Technical Note 1

Project: Hill Lane, Markfield

Title: Response to LCC Consultation – Planning Application 25/01157/OUT

Date: 25.03.2026

TITLE
PROPOSED SITE ACCESS JUNCTION

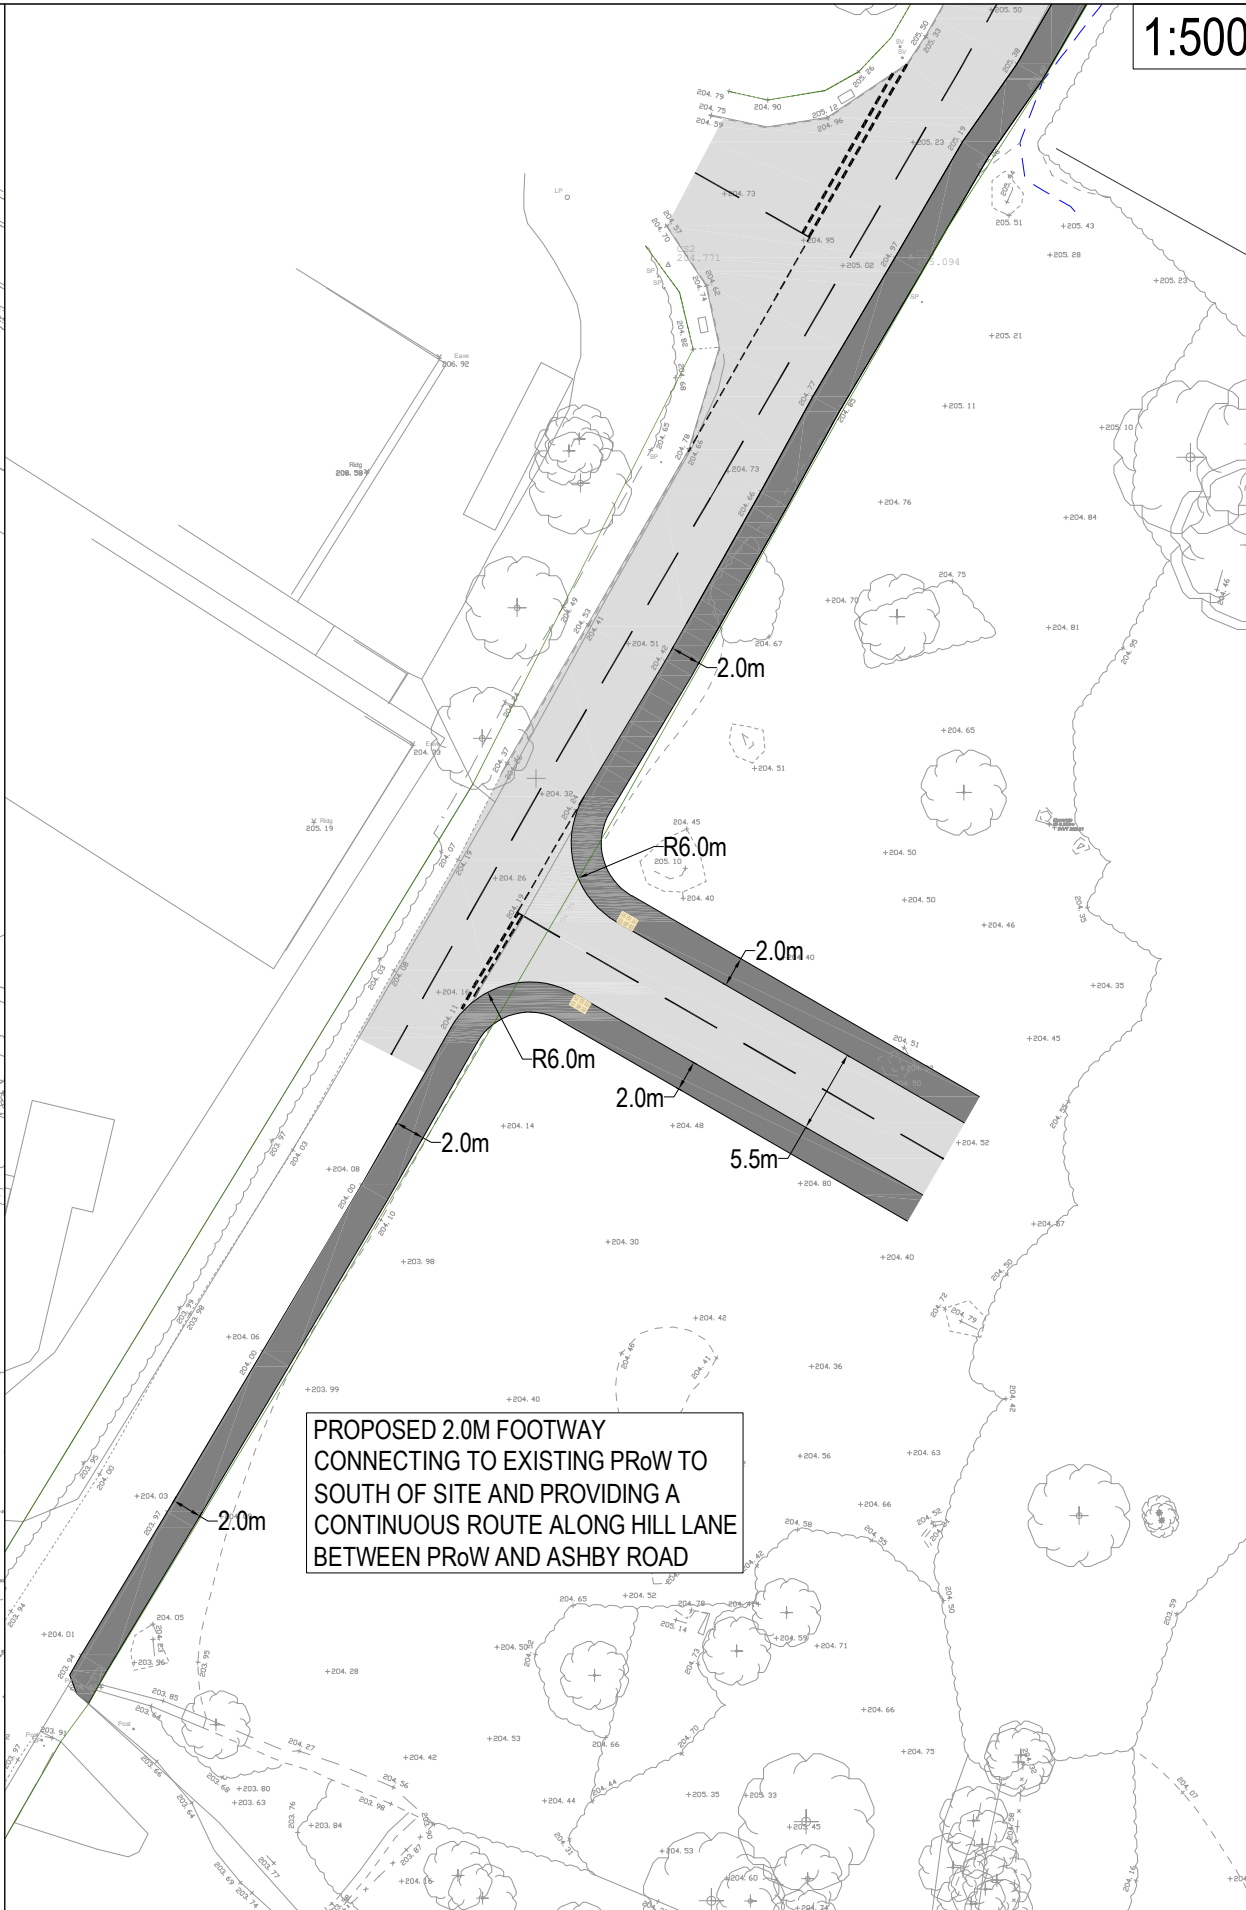
'The LHA confirm, that in terms of geometry, the access has been designed in accordance with Table 3 and Table 9 of the LHDG. An uncontrolled pedestrian crossing with tactile paving is to be provided just inside the site access. It must be ensured that pedestrians at the crossing points will have suitable visibility of vehicles travelling on Hill Lane and approaching from within the site'.

'As shown on drawing No. T25596 007 an uncontrolled pedestrian crossing with tactile paving is also proposed on Ashby Road to provide access to a bus stop. The carriageway width should be confirmed at this location to determine the safe crossing distance and visibility lines'.

'The addition of the above footways will result in a reduction of the carriageway width of Hill Lane to 6.30m. The LHA request that drawing No. T25596 001 is amended to show existing overall carriageway widths along with lane widths. Swept path analysis drawings should be annotated to state tracking has been undertaken at a forward vehicular speed of 15kph and should be shown for an 18.55m long HGV which is the maximum length currently permitted in the UK'.

- 1.8 As a result of these comments provided by LCC, **Drawing T25596.001 Rev A** attached to this report identifies 1.5m x 17m pedestrian visibility splays from either side of the proposed dropped kerb pedestrian crossing point to the nearside channel lines along the site access road and Hill Lane.

- 1.16 **Drawing T25596.001 Rev A** identifies that the 2.0m wide footway proposed adjacent to the eastern side of Hill Lane is continuous up to the footway provision adjacent Ashby Road to the north, with the existing access to the rear car parking associated with dwellings served from Ashby Road to be provided in the form of a dropped kerb crossover arrangement, therefore giving priority to pedestrians along the proposed footway.

- 1.17 This drawing also includes annotations along Hill Lane of the overall carriageway width, lane widths in each direction and the width of the on-street parking area adjacent to the west side of the carriageway, south of the junction with Ashby Road.

TITLE
SWEPT PATH ANALYSIS 01

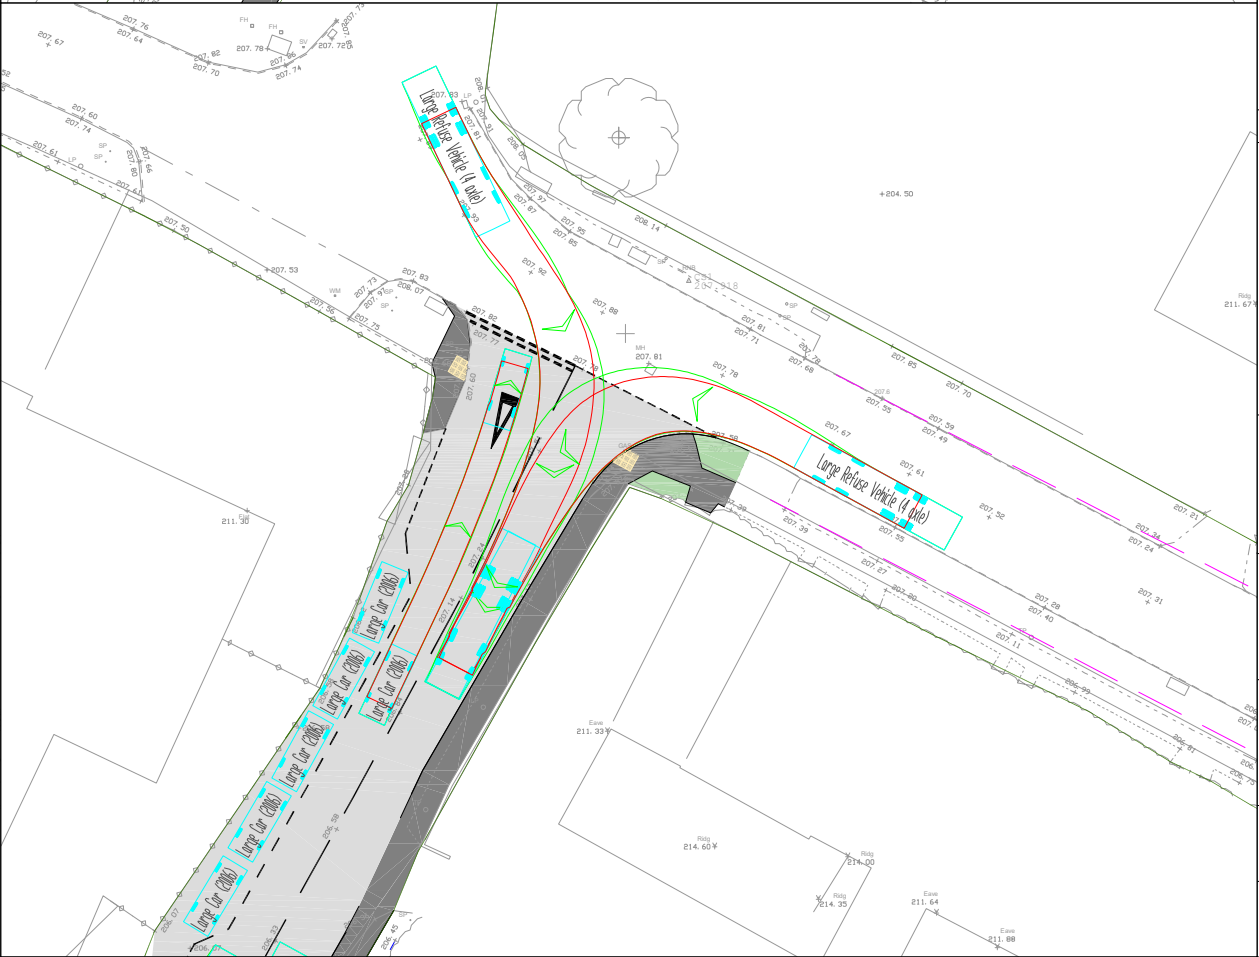
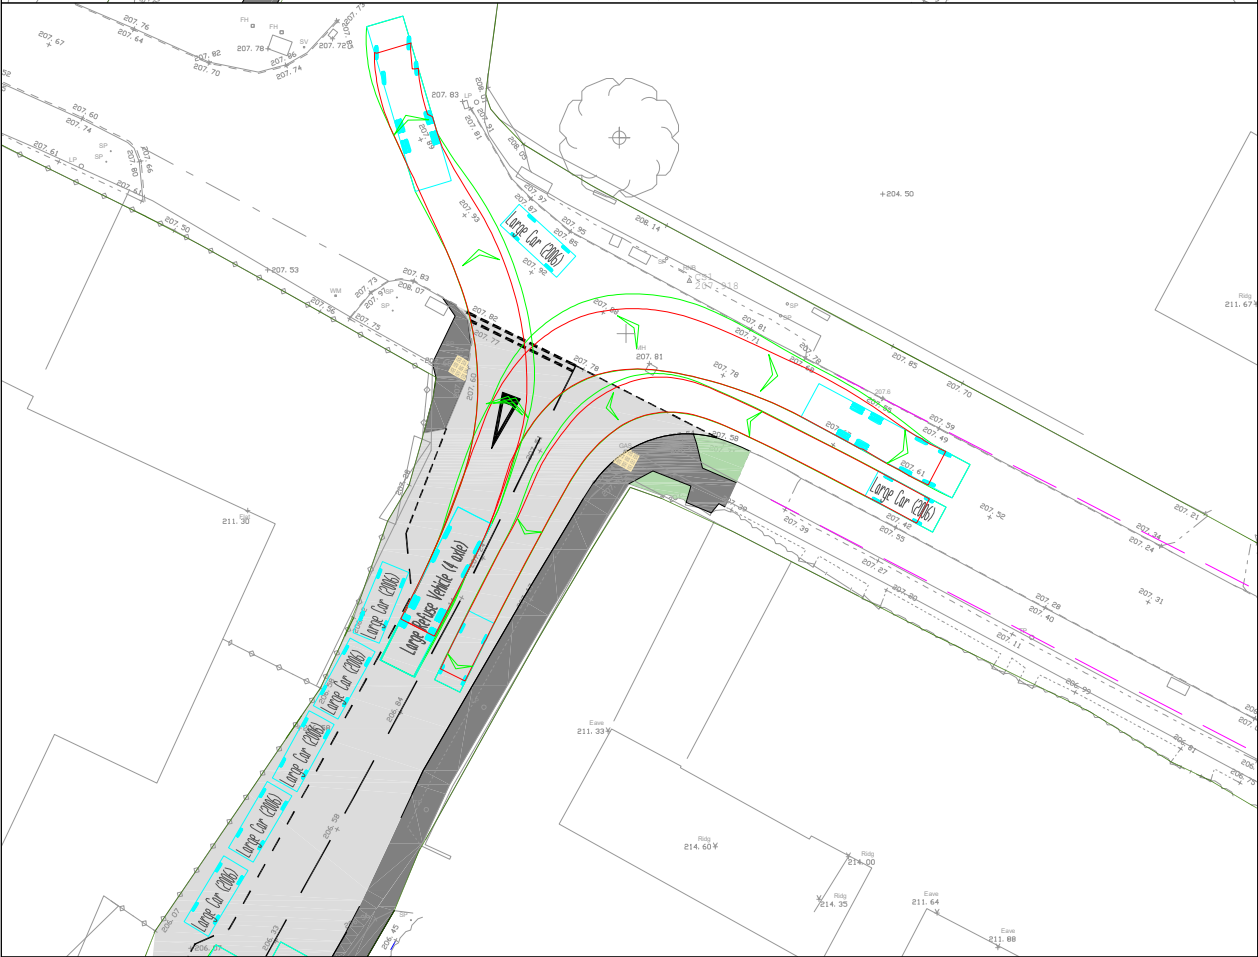
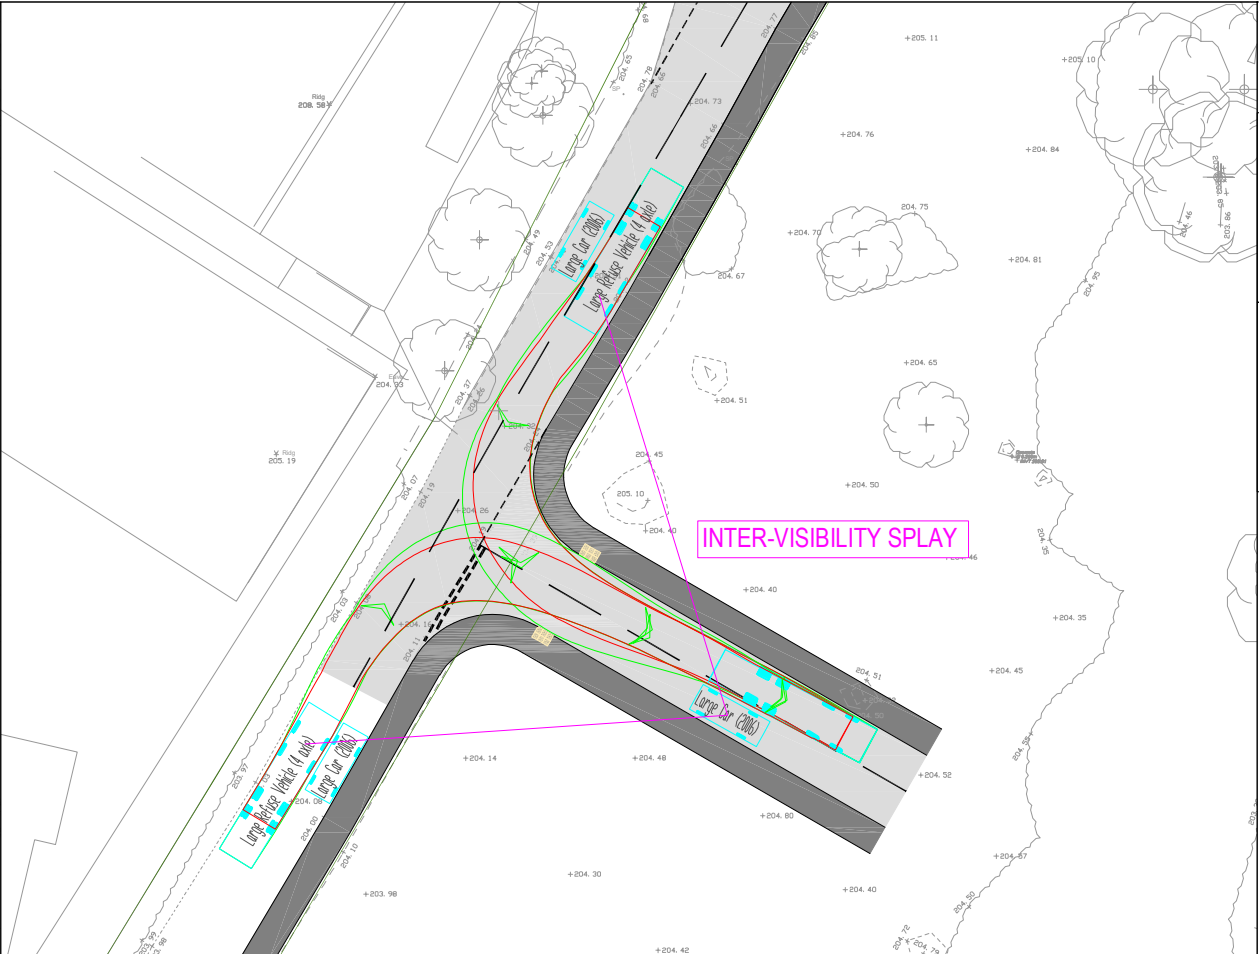
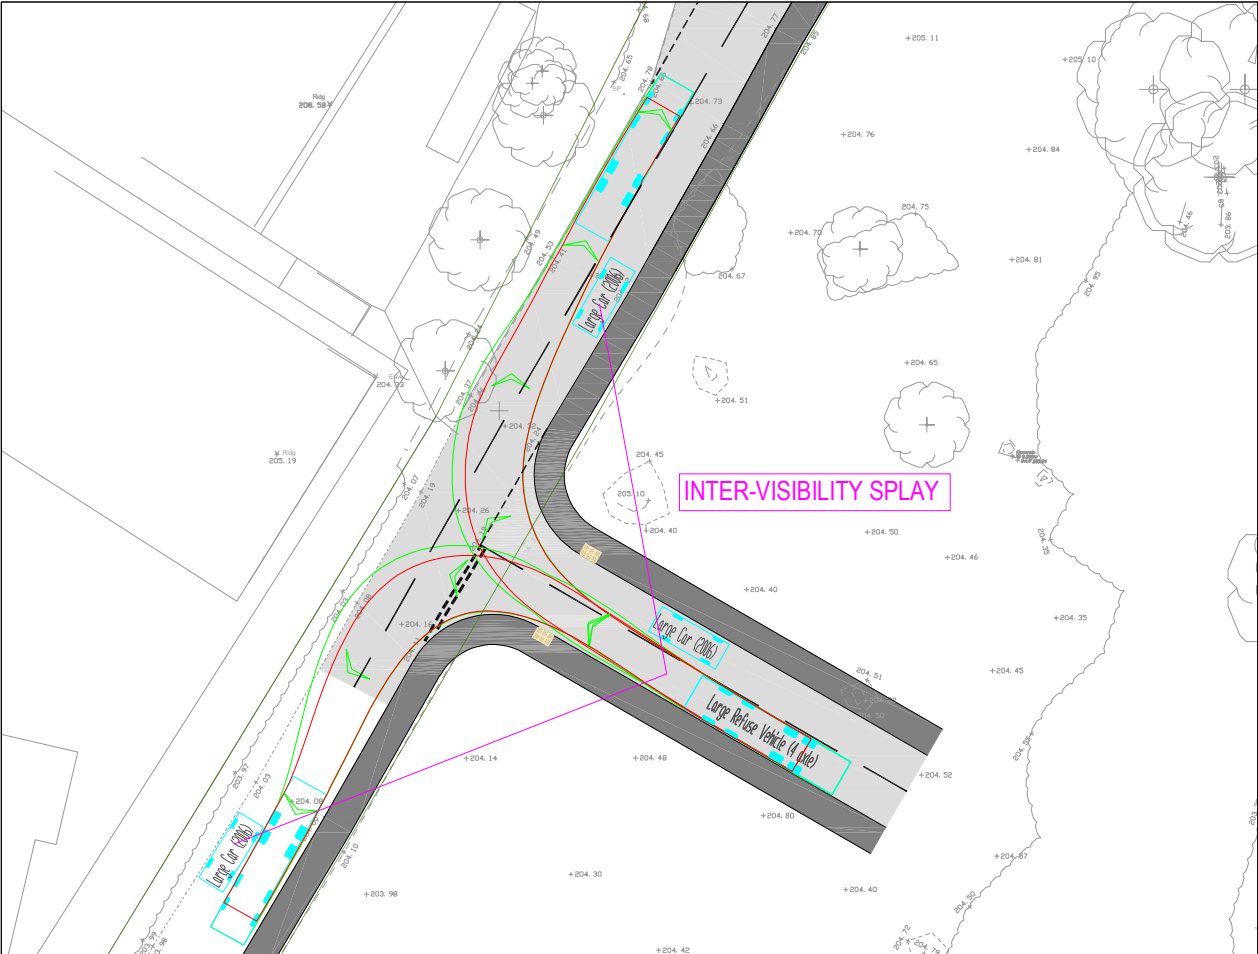
'Drawing No. T25596 002 shows refuse vehicle movements at the site access. The LHA note that for both the right turn in and right turn out manoeuvres the vehicle is required to occupy most of the access. The Applicant should demonstrate that suitable intervisibility can be provided to prevent conflict between larger and smaller vehicles'.

'The swept path analysis drawings should be annotated to confirm tracking has been undertaken at a forward vehicular speed of 15kph'.

- 1.10 **Drawing T25634.002 Rev A** identifies the inter-visibility splays between the site access and Hill Lane, where two-way Large Car/LCC Refuse Vehicle movements cannot be accommodated. These visibility splays will be unobstructed and short in length, with the greatest length of inter-visibility splay shown within **Drawing T25634.002 Rev A** to be 30m.

- 1.11 This drawing therefore demonstrates that the driver of a Large Car is able to identify the LCC Refuse Vehicle turning into/out of the site access junction from a reasonable distance back to where the refuse vehicle would be able to pass the Large Car without reversing manoeuvres being required.

- 1.12 Each of the drawings that include swept path assessments, attached to this TN, have been run at a forward vehicular speed of 15kph, which is stated within the Notes of each drawing that include swept path analysis.
